CITY OF ALBUQUERQUE

**RE: Isburg Residence
6316 Tesuque Dr. NW
Grading and Drainage Plan
Engineers Stamp Date 4/29/2020 (E10D077)**

Based upon the information provided in your submittal received 4/27/2020, this plan cannot be approved for Grading Permit until the following comments are addressed:

GRADING AND DRAINAGE PLAN

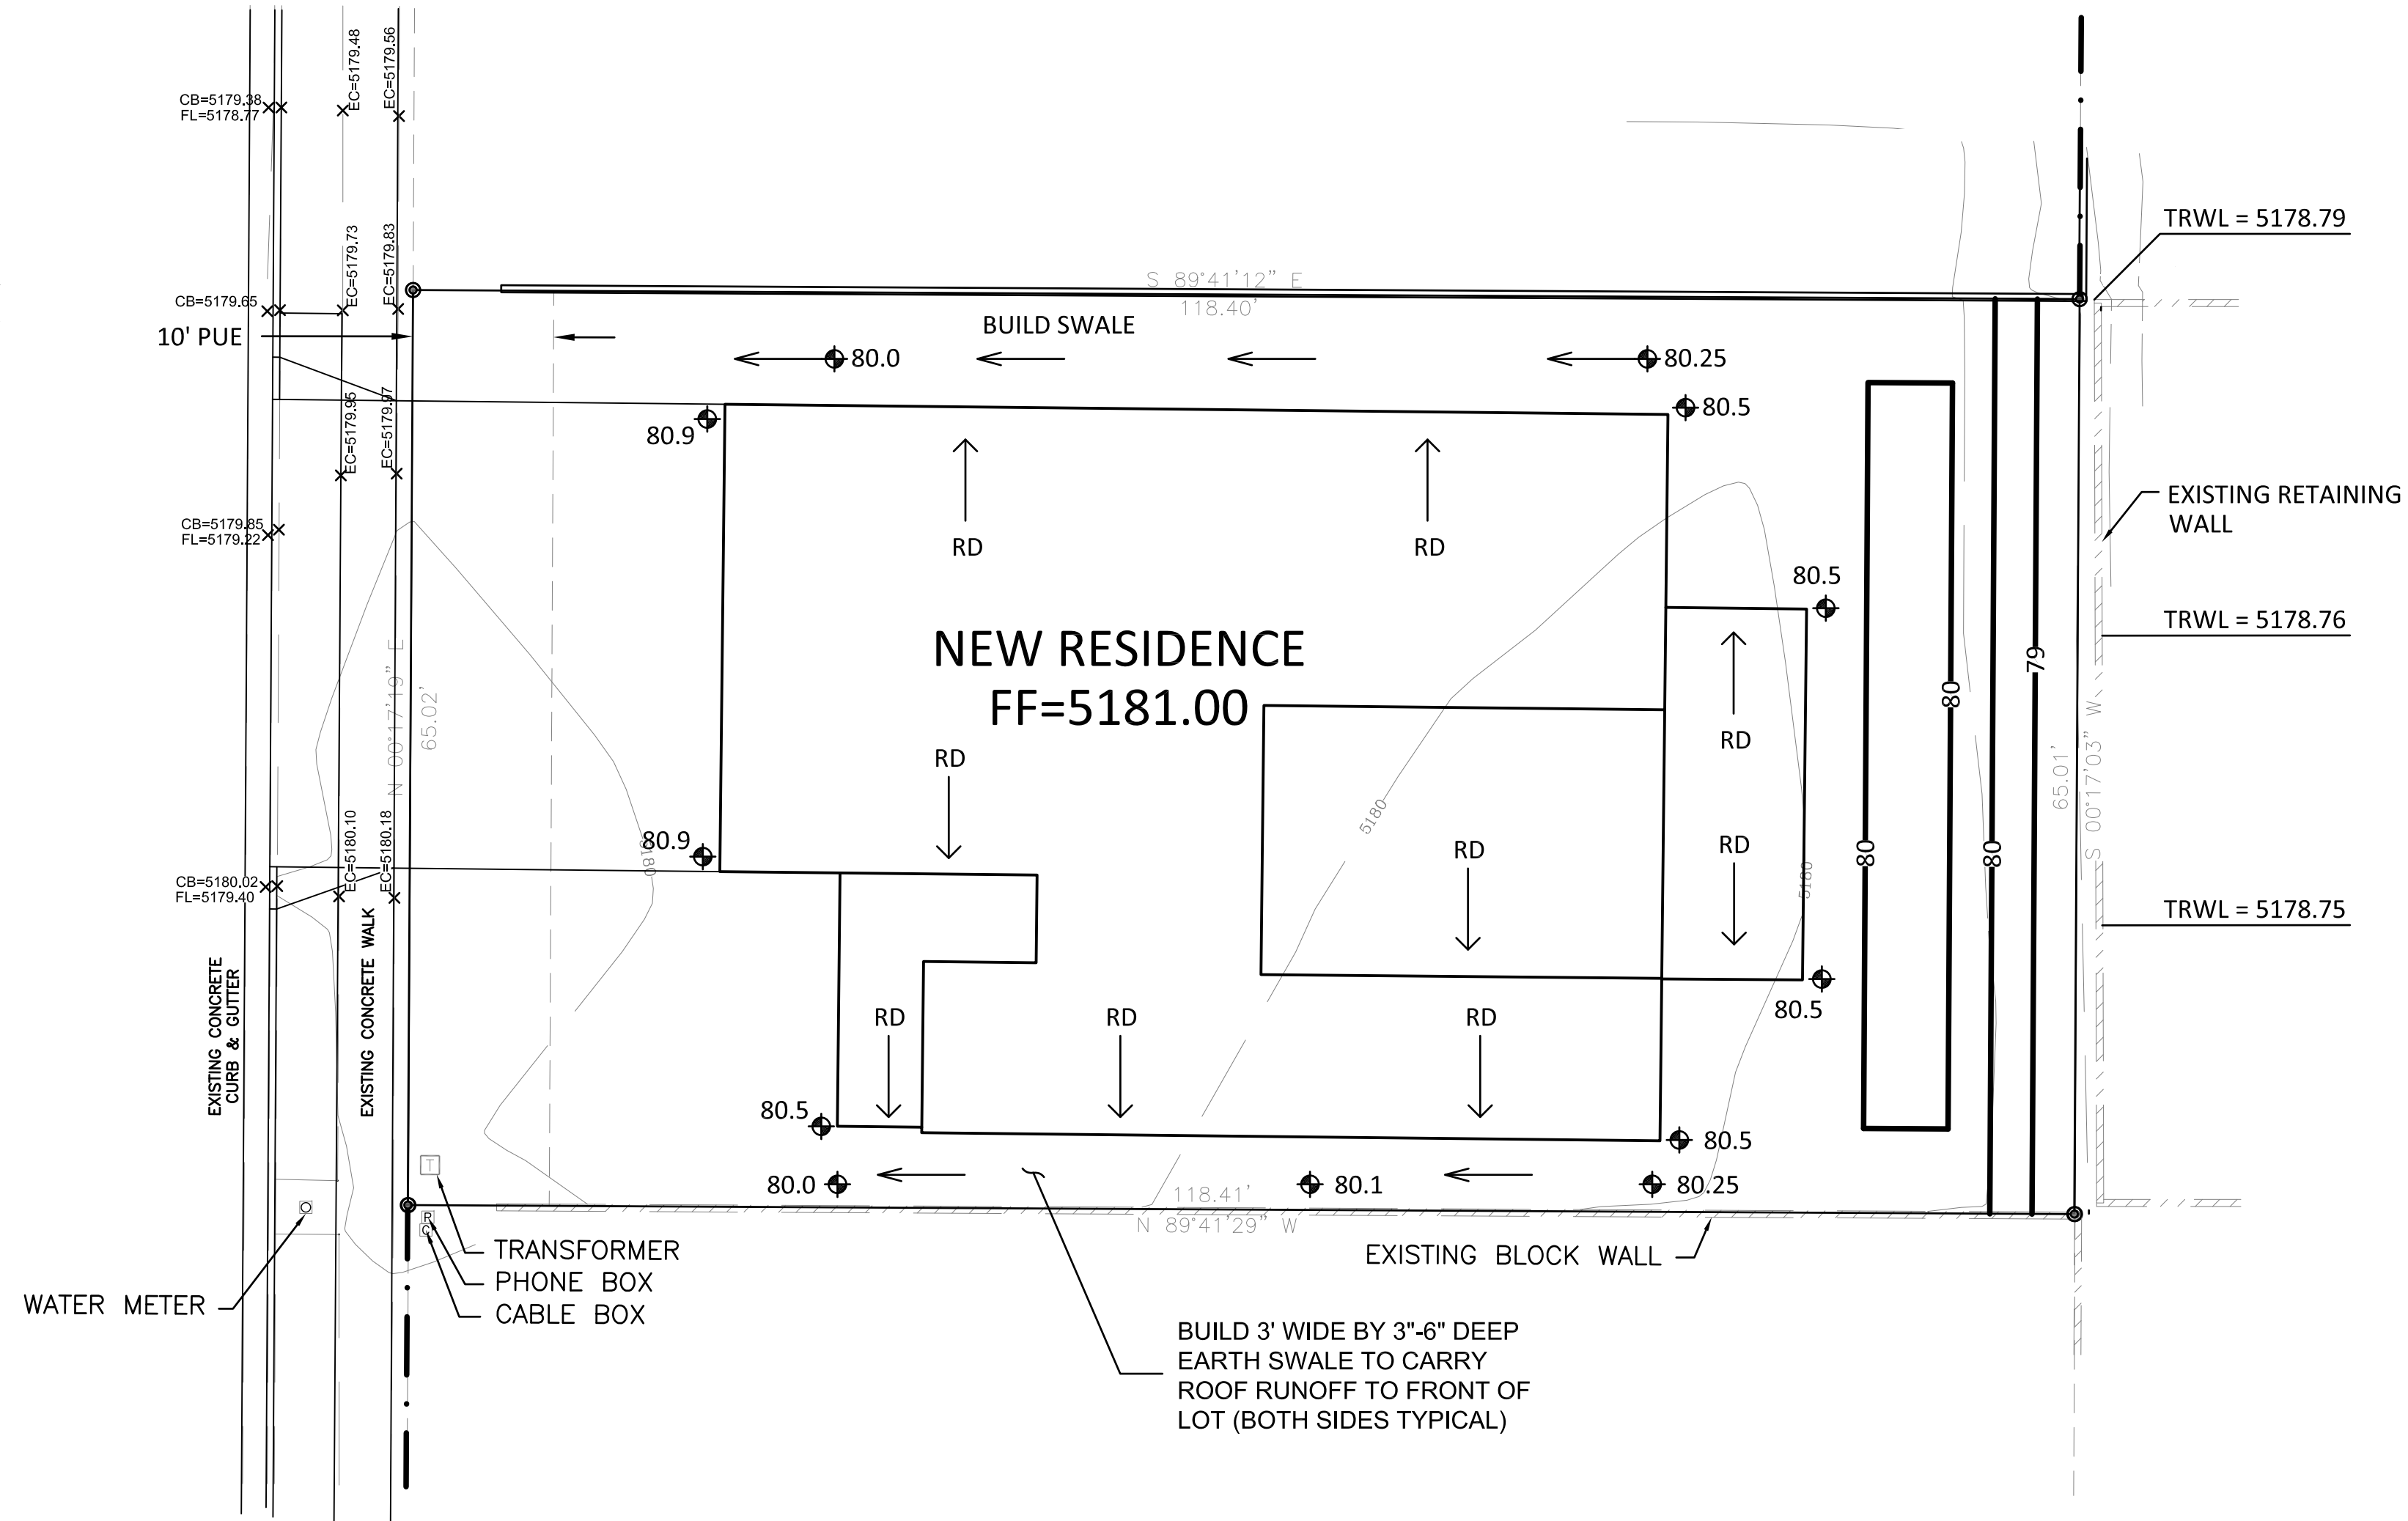
- Grade the entire rear yard elevation to 80.5.
- Provide profiles for the swales, showing gravel as the base.
